APPROVED
Building Division

SCALE: 1/4" = 1'-0" LEFT ELEVATION "C"

SCALE: 1/4" = 1'-0" SECOND FLOOR PLAN-ELEY. TYPE "C"

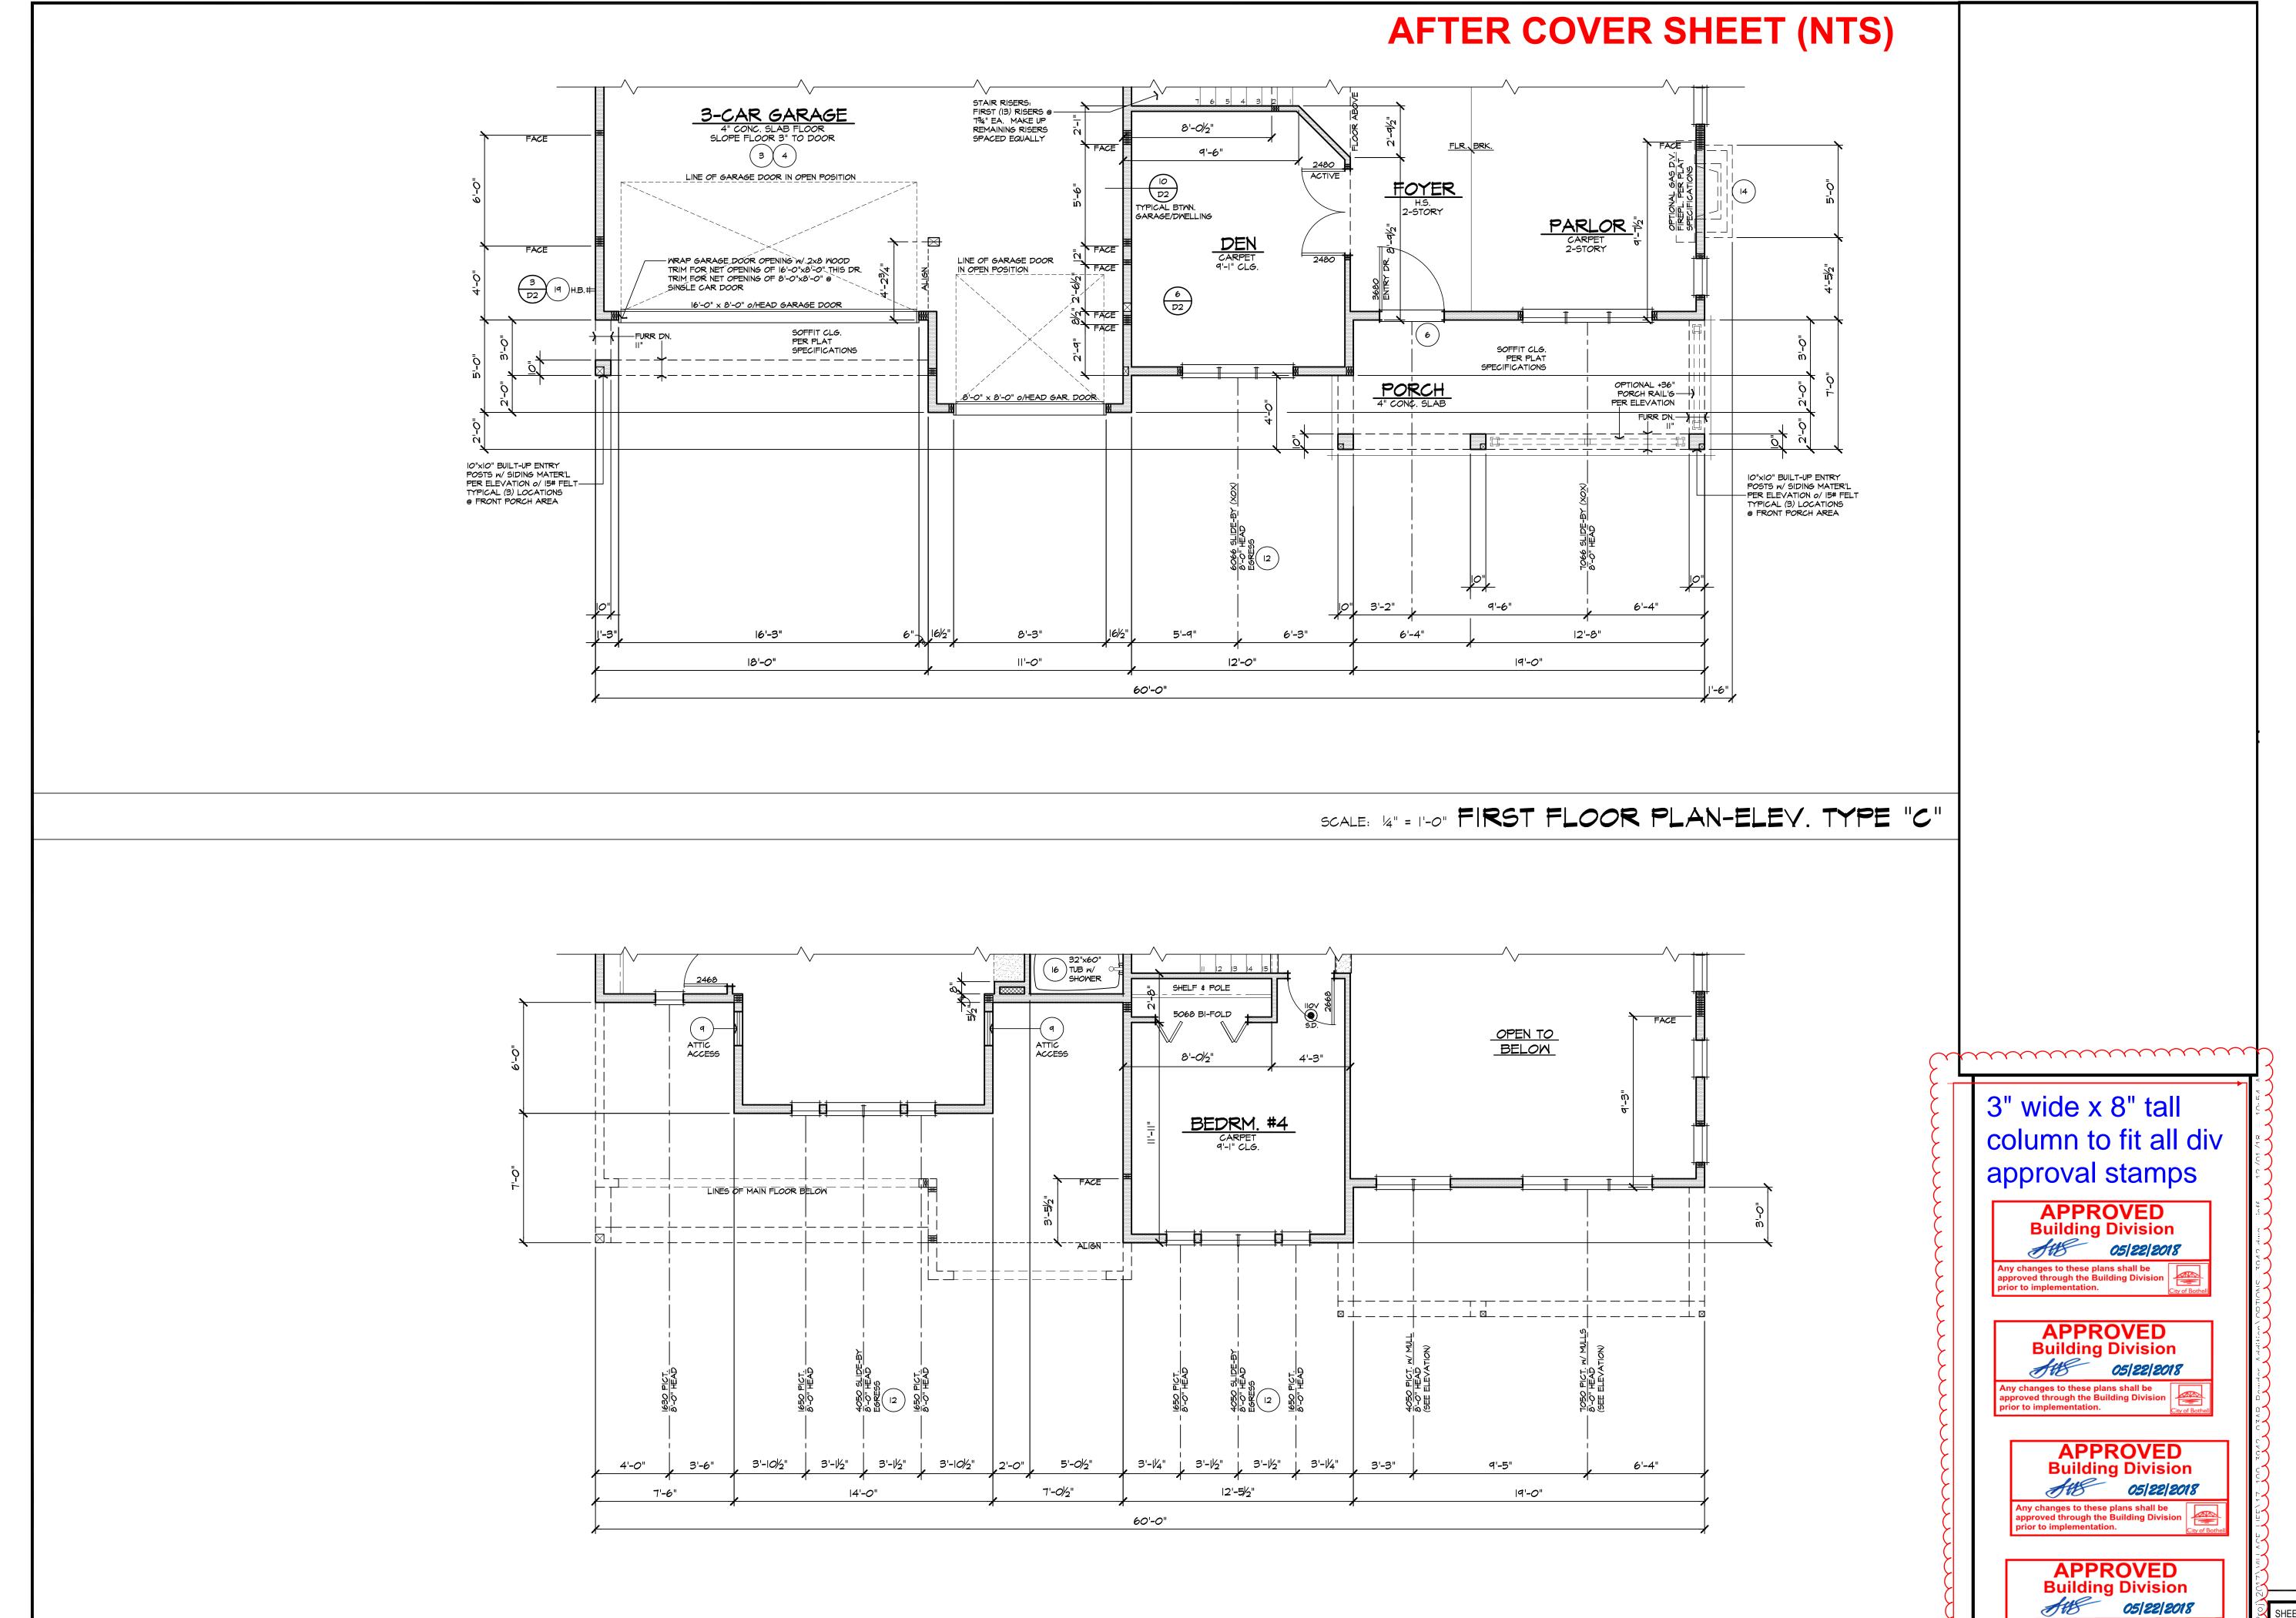
NOTE: THE APPLICANT SHALL FIELD VERIFY THE INVERT ELEVATION OF THE STORM DRAIN CONNECTION FOR THIS LOT PRIOR TO PLACEMENT OF FOOTINGS. THE BOTTOM OF THE LOWEST FOOTING SHALL BE HIGH ENOUGH TO ALLOW POSITIVE GRAVITY FLOW TO THE STORM DRAIN CONNECTION.

ALL EROSION CONTROL DEVICES MUST BE INSPECTED AND APPROVED PRIOR TO FOOTING INSPECTION ON ALL SLOPED LOTS. SEE BMC 17.52

ALL FOOTING AND ROOF DRAINS REQUIRED TO BE INSPECTED PRIOR TO COVER AND BACKFILL.

LOT SPECIFIC GEOTECH REPORT IS REQUIRED AT THE TIME OF THE FOOTING INSPECTION

PRESSURE AND REDUCING VALVES
REQUIRED ON BUILDING SUPPLY LINE IF
SERVICE PRESSURE EXCEEDS 80 PSI

BUILDING HEIGHT VERIFICATION & CERTIFICATION BY A LICENSED SURVEYOR SHALL BE PROVIDED TO THE BUILDING DEPARTMENT AS REQUIRED AT THE TIME OF FRAMING INSPECTION. BMC 12.14.110

FASTENERS FOR PRESSURE TREATED WOOD SHALL BE OF HOT-DIPPED GALVANIZED STEEL OR STAINLESS STEEL EXCEPT 1/2 INCH DIAMETER OR GREATER STEEL BOLTS.

CALL FOR UNDER FLOOR FRAMING INSPECTION PRIOR TO PLACING FLOOR SHEATHING.

ALL VERTICAL REBAR MUST BE TIED IN PLACE PRIOR TO THE FOOTING INSPECTION.

A FIRE SUPRESSION PERMIT SHALL BE OBTAINED PRIOR TO THE FRAMING INSPECTION. MULTI-PURPOSE PIPING SYSTEMS SHALL BE INSTALLED BY A LICENSED FIRE PROTECTION SPRINKLER CONTRACTOR.
